EXISTING CONDITIONS PROPOSED SITE PLAN ANNA FASCITELLI WELLNESS AND FITNESS CENTER WELLNESS AND FITNESS CENTER UNIVERSITY OF RHODE ISLAND

DEPARTMENT OF ENVIRONMENTAL MANAGEMENT
OFFICE OF WATER RESOURCES
FRESHWATER WETLANDS PROGRAM
APPROVED WITH CONDITIONS
AS SPECIFIED IN THE LETTER OF APPROVAL
DATED **JAN 19 2011** FILE # **10-0175**
NO CHANGES ALLOWED WITHOUT PRIOR APPROVAL
APPROVED PLANS MUST BE AT CONSTRUCTION SITE

SHEET TITLE
PROPOSED SITE PLAN

PROPOSED SITE PLAN
 WELLNESS AND FITNESS CENTER
 UNIVERSITY OF RHODE ISLAND

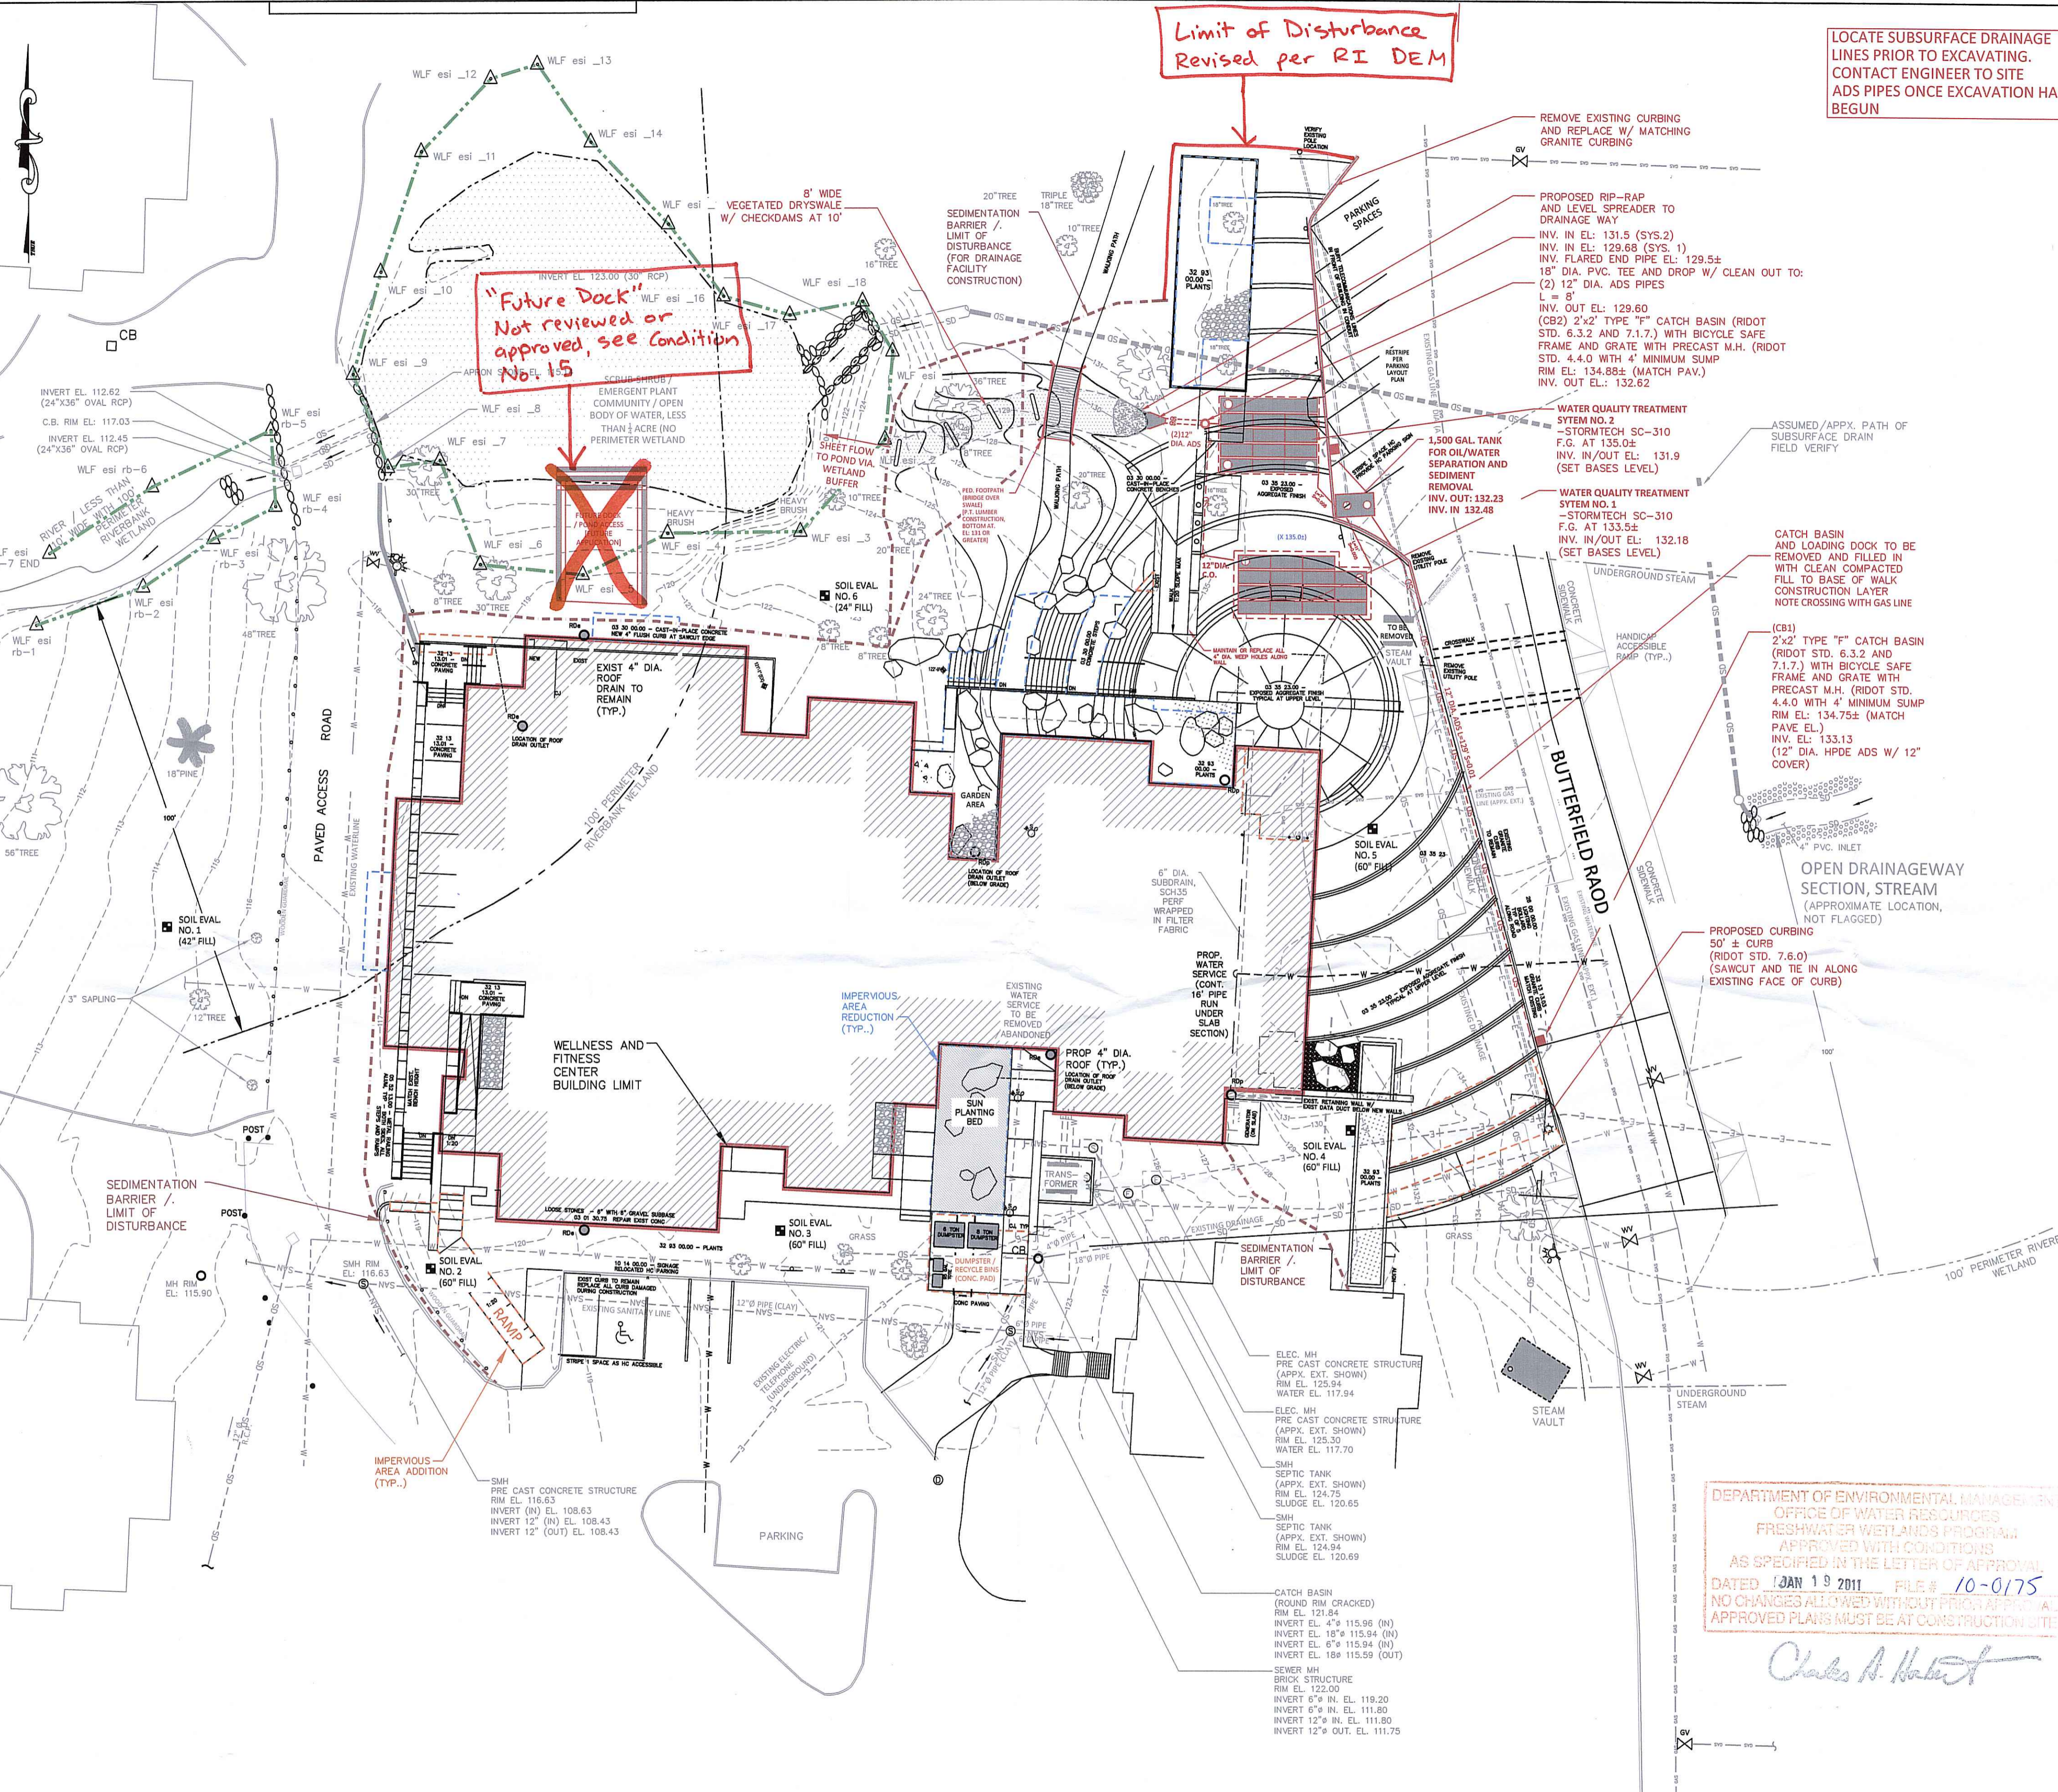
Limit of Disturbance Revised per RI DEM

"Future Dock" Not reviewed or approved, see Condition No. 15
